**Tradition Master Planned Unit Development 14<sup>th</sup> Amendment  
MPUD Amendment Application  
P22-097**

Applicant's Request:	A request to amend the Tradition MPUD (Master Planned Unit Development) zoning regulation book and concept plan for property identified as parcels 17, 17 A, and 18 on the Tradition MPUD concept plan (14 <sup>th</sup> Amendment)
Applicant:	Steve Garrett, Lucido and Associates
Property Owner:	Mattamy Palm Beach, LLC
Location:	The subject property is generally bordered by SW Westcliffe Lane to the north, Tradition Parkway to the south, SW Fernlake Drive to the east, and future N/S A to the west.
Address:	Not assigned
Project Planner:	Bridget Kean, AICP, Senior Planner

# Tradition MPUD - 14th Amendment Exhibit

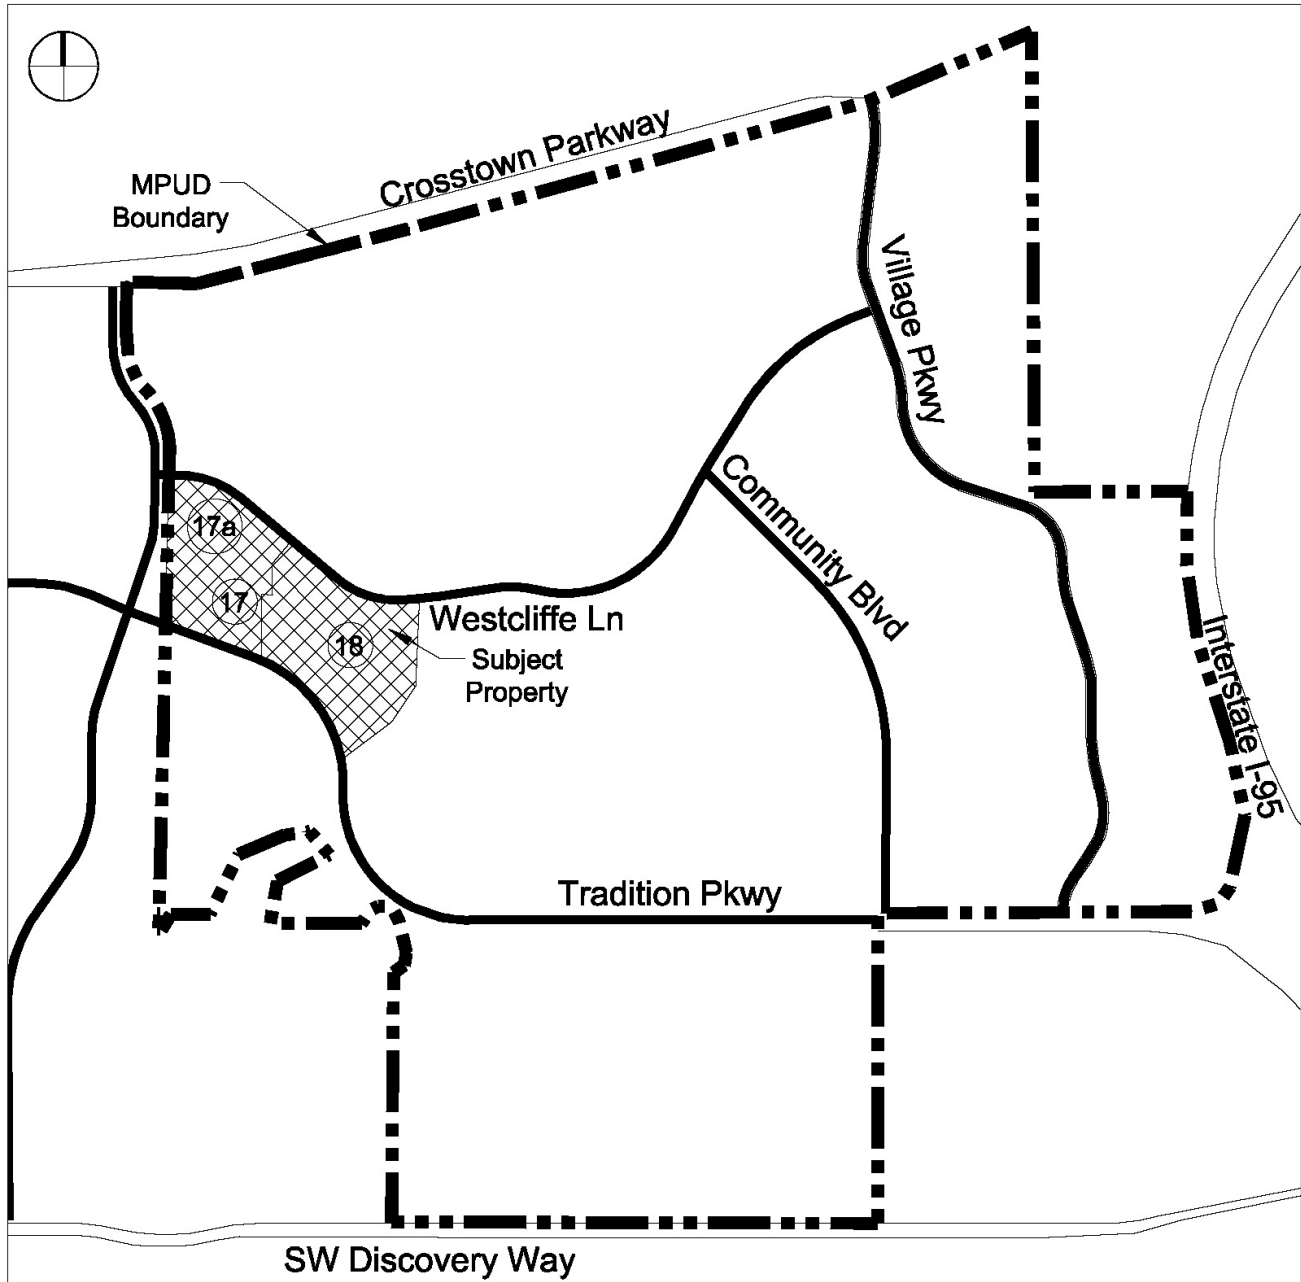
The proposed amendment revises the land use sub-area designation for Parcels 17 and 17A from the Town Center sub-area to the Residential sub-area on the MPUD concept plan and adds updated development standards for single-family and multi-family residential development for Parcels 17, Parcel 17A, and Parcel 18. The subject area of this application is shown below:

1. Revise the MPUD concept plan (Exhibit 8B) and development tables (Exhibit 5) to change the sub-area designation on 31.59 acres identified as Parcels 17 and 17 A from the Town Center sub-area to the Residential sub-area as shown on proposed Exhibit 8B.
